CPED STAFF REPORT

Prepared for the Heritage Preservation Commission
 HPC Agenda Item #4
 May 17, 2016
 BZH-29104

Property Location: 201 2nd Avenue Southeast
Project Name: St. Anthony Ramp Exterior Renovation
Prepared By: Janelle Widmeier, Senior City Planner, (612) 673-3156
Applicant: St. Anthony Ramp LLC
Project Contact: Steven Faber, St. Anthony Ramp LLC
Ward: 3
Neighborhood: Marcy Holmes
Request: To allow exterior alterations to a parking ramp, including a canopy addition and signage.

Backlit P Sign (2): 4'-0" x 4'-0"

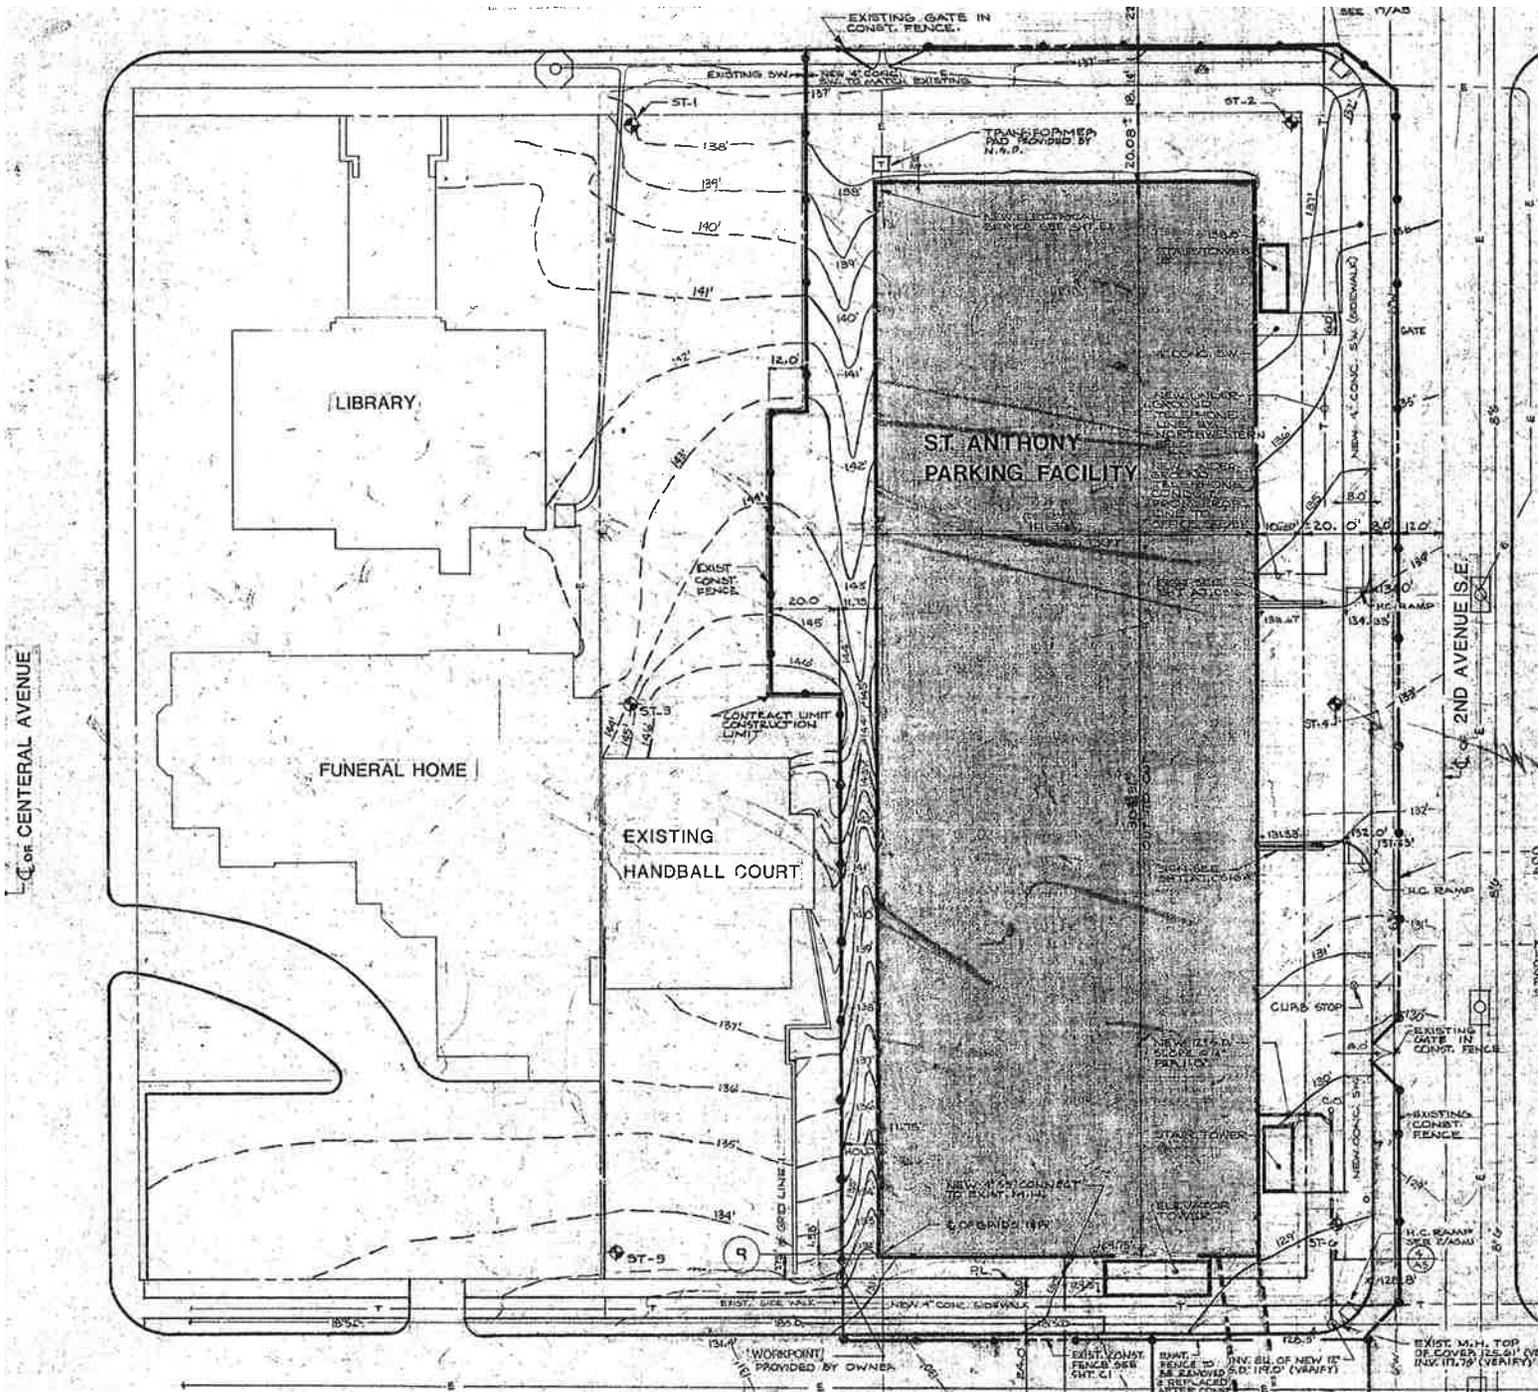
In the Design Guidelines for On-Premise Signs and Awnings, backlit signs are not appropriate for historic districts. The freestanding signs that would be relocated on the ground after the half-walls are removed are backlit. Because the sign cabinets would be reused, staff is recommending that the

signs be changed to internal or external illumination. The replacement walls signs would be nonilluminated and would not increase in size.

1. The freestanding signs shall not be backlit.
2. By ordinance, approvals are valid for a period of two years from the date of the decision unless required permits are obtained and the action approved is substantially begun and proceeds in a continuous basis toward completion. Upon written request and for good cause, the planning director may grant up to a one year extension if the request is made in writing no later than May 17, 2018.
3. By ordinance, all approvals granted in this certificate of appropriateness shall remain in effect as long as all of the conditions and guarantees of such approvals are observed. Failure to comply with such conditions and guarantees shall constitute a violation of this Certificate of Appropriateness and may result in termination of the approval.
